Subject RE: Salmon Arm TCH 2WLT Concept Sketch - Compromise!

Subject: Salmon Arm TCH 2WLT Concept Sketch - Compromise!

Subject: RE: Salmon Arm TCH 2WLTL Concept Sketch

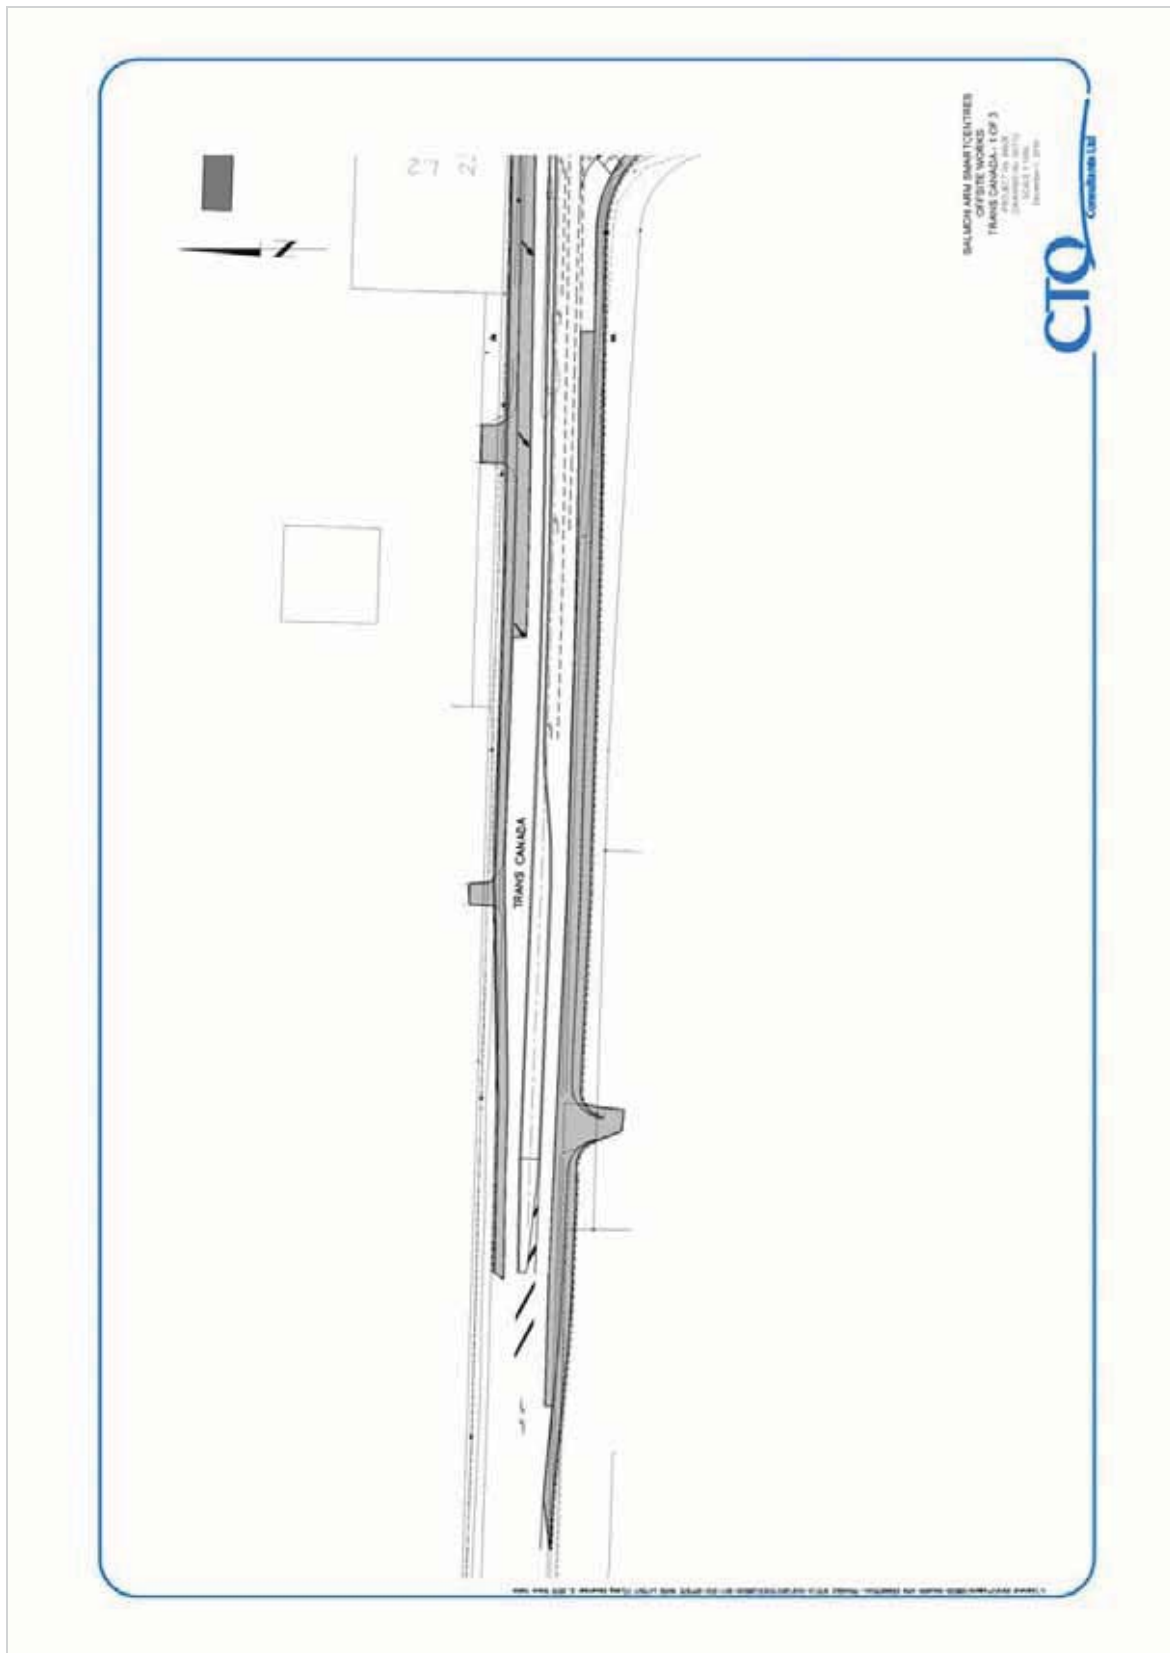
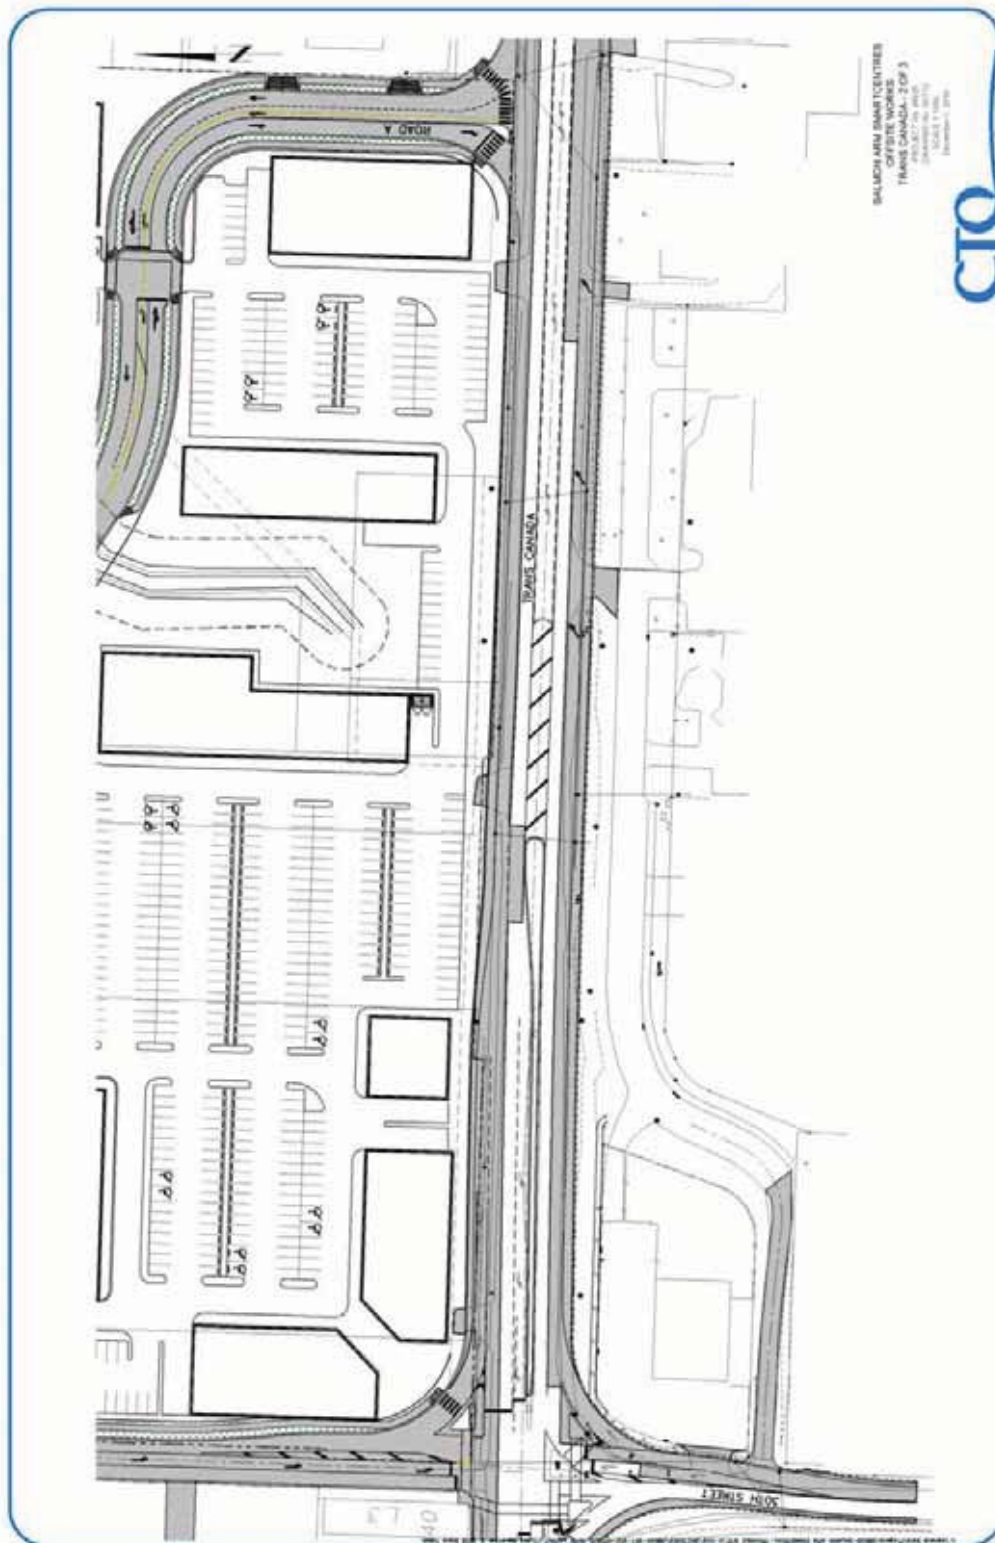
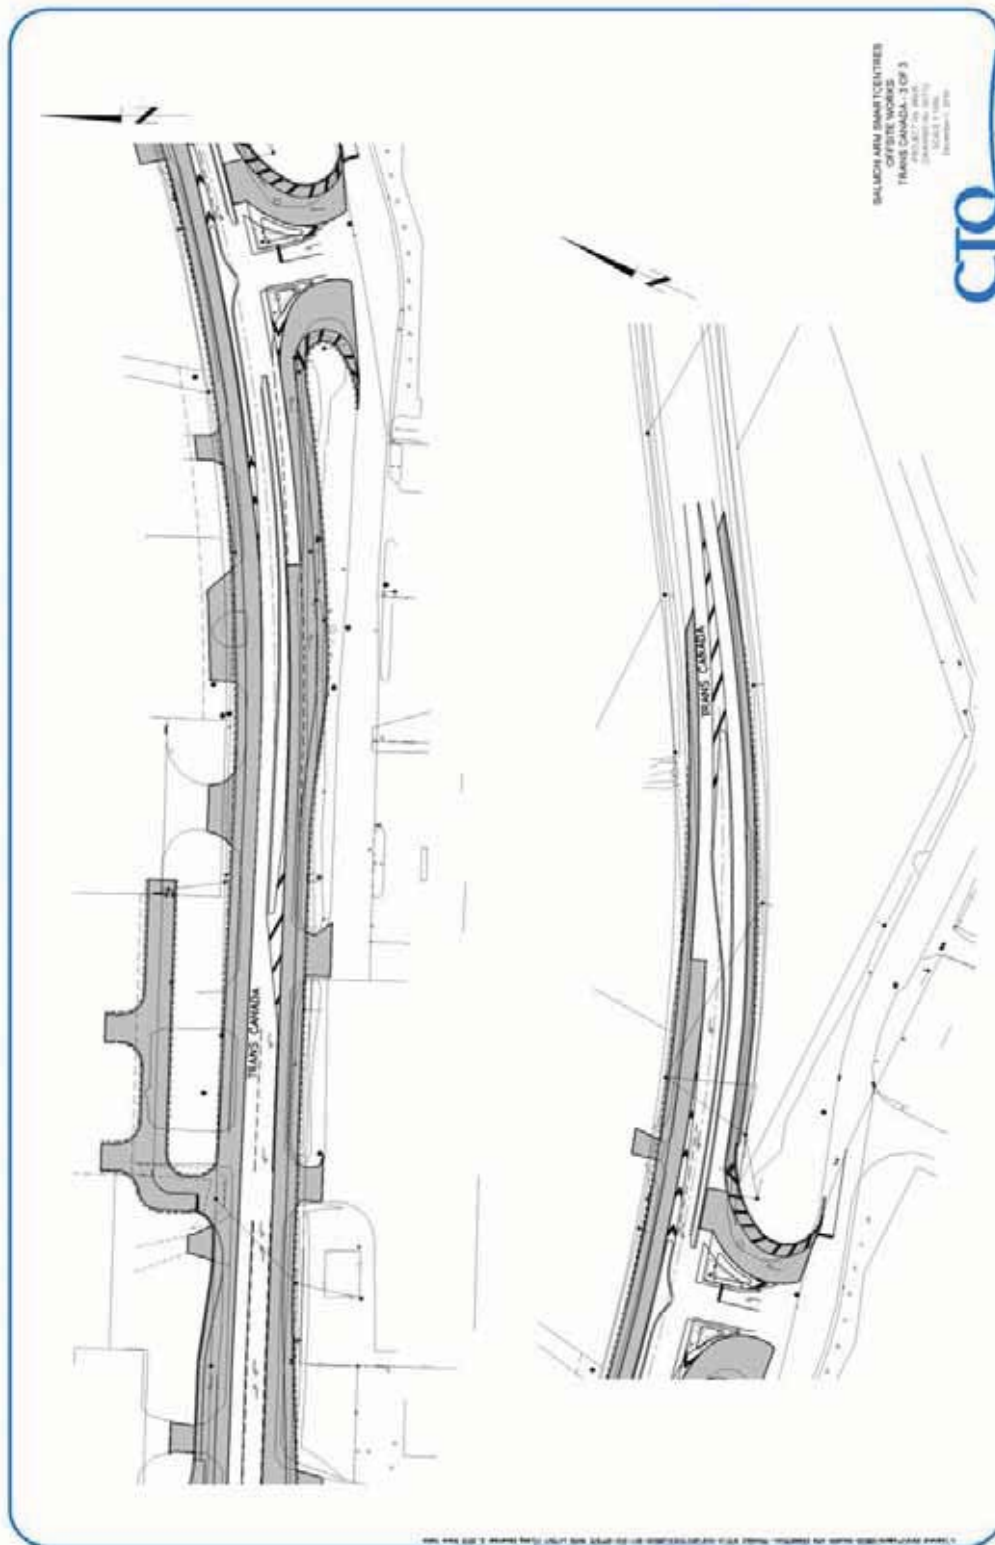
Having to prepare this sketch made me discover that there was an error in the assumptions in my notes – Distance 'A' in the Ministry's Figure 710.D.1 does not apply in this case as the centre acceleration lane for the left turn movements out of 10 Avenue actually becomes the second through lane on the highway. Consequently, we now have a greater distance available for the weave – 90 metres.

Note that the location marked 'W' on the protected 'T' is what I consider the key pivotal point – we cannot widen at this point without obtaining additional right-of-way on the north side of the highway or restricting the size of trucks that can make the 180 degree 'U' turn from the TCH eastbound into the Frontage Road westbound.

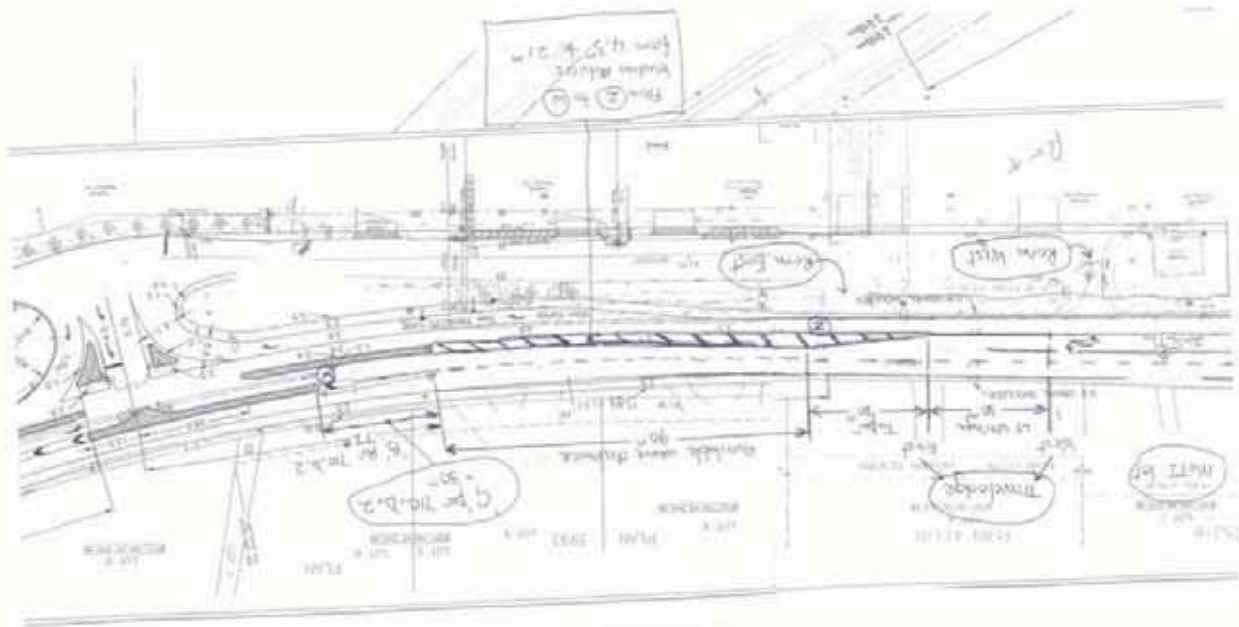
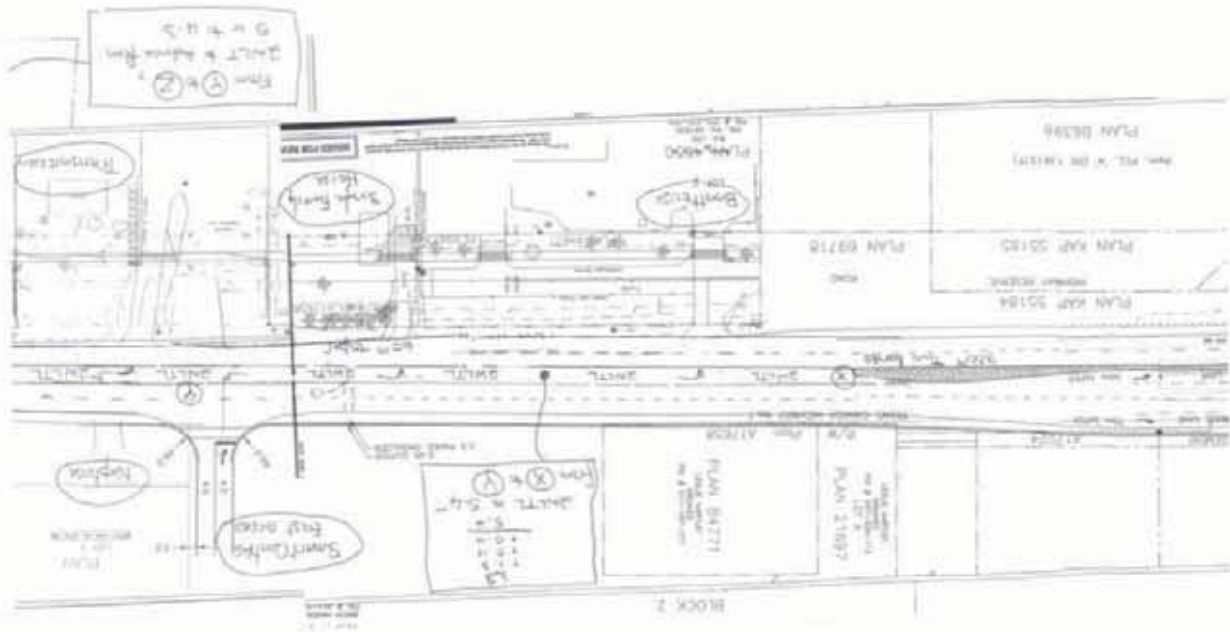
Having to prepare this sketch made me discover that there was an error in the assumptions in my notes – Distance 'A' in the Ministry's Figure 710.D.1 does not apply in this case as the centre acceleration lane for the left turn movements out of 10 Avenue actually becomes the second through lane on the highway. Consequently, we now have a greater distance available for the weave – 90 metres.

Because of this, I have also increased the storage distance for the left turn movement into the Rona West access – It is shown as 30 metres but I now have it starting at the Travelodge West access so it is effectively 35 metres storage for the Rona West access.

Note that the location marked 'W' on the protected 'T' is what I consider the key pivotal point – we cannot widen at this point without obtaining additional right-of-way on the north side of the highway or restricting the size of trucks that can make the 180 degree 'U' turn from the TCH eastbound into the Frontage Road westbound.
